CHUGACH ELECTRIC ASSOCIATION, INC.  
Anchorage, Alaska

ADDENDUM #1

E2420080 – South Campus Pole Relocation – Phase 2

DRAWING NAME:		138kV TRANSMISSION LINE INTL TRANSMISSION - ROBERT RETHERFORD SITE & STRUCTURAL PROPOSED PLAN	
<b>CONFIDENTIAL</b>		INSS-SS-0004-0001	
DRAWING NO. - PREVIOUS/REFERENCE		SHEET 0001 OF 1	
DRAWING NO.:		INSS-SS-0004	
NEW		PAGE OF

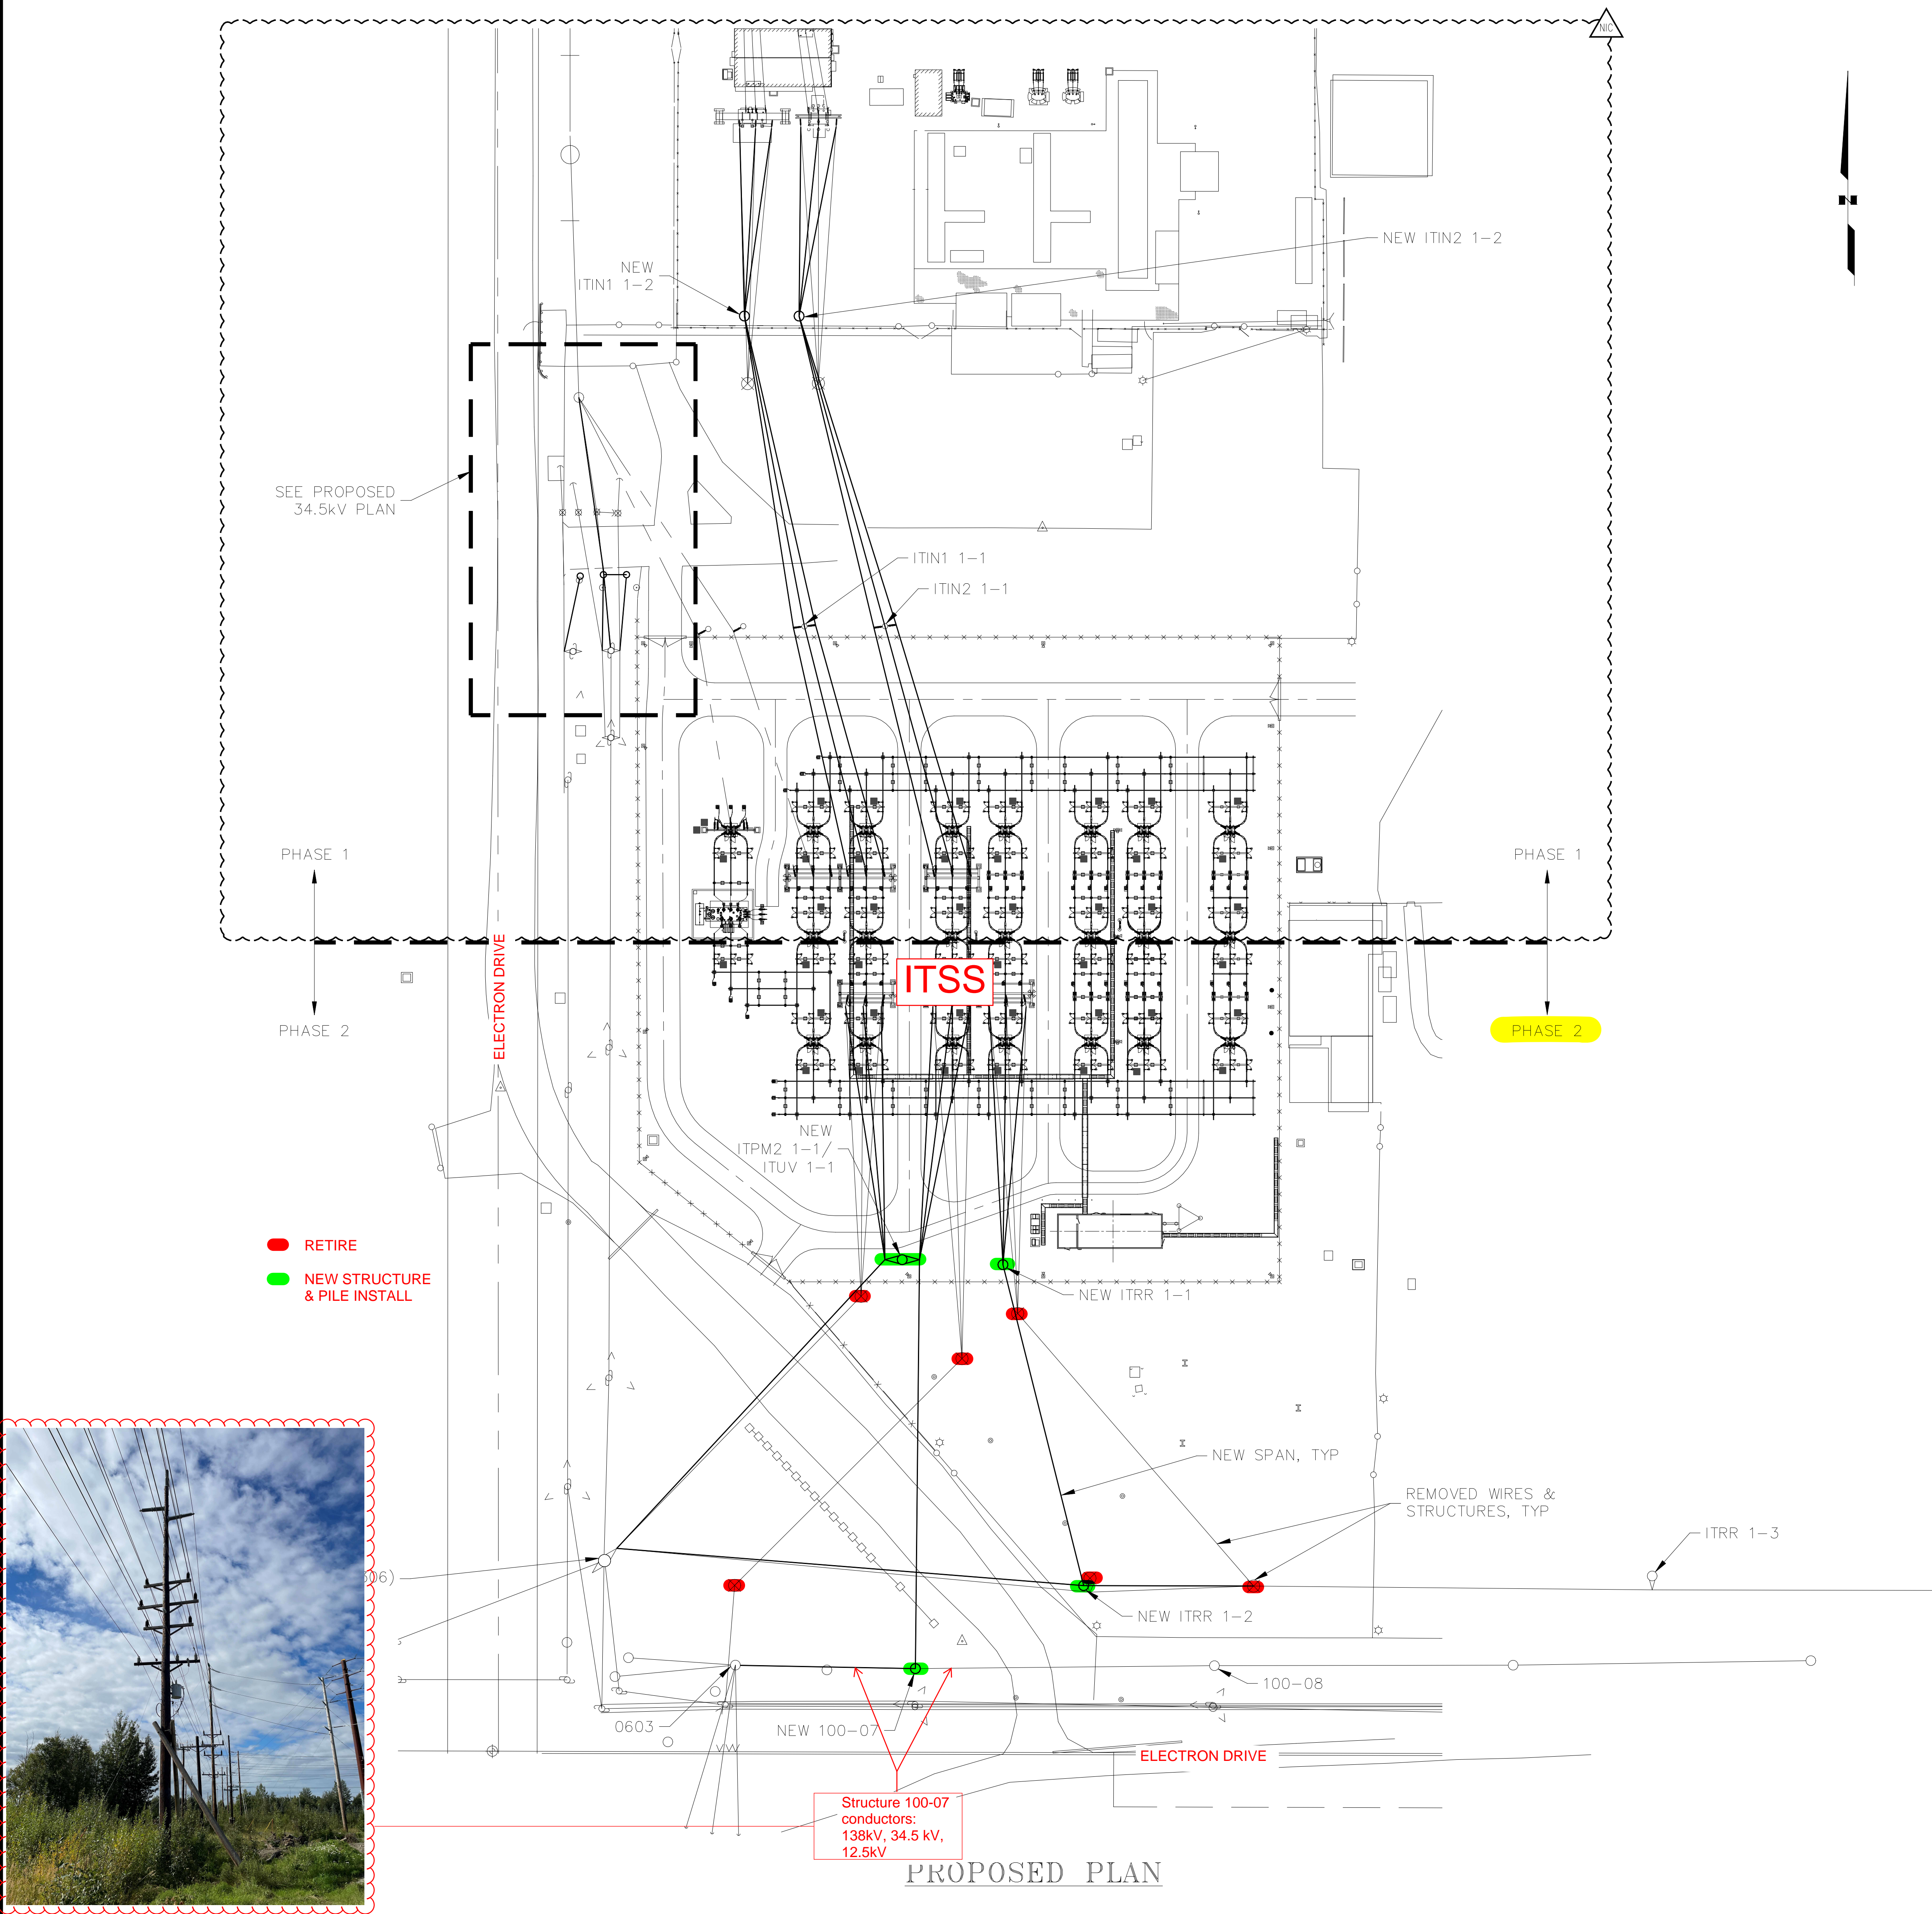
1. Pre-bid Meeting Agenda.
2. Drawing Propose Plan Sheet INSS-SS-0004.
3. Bid Questions & Answers.
4. Pre-Bid Sign in Sheet.
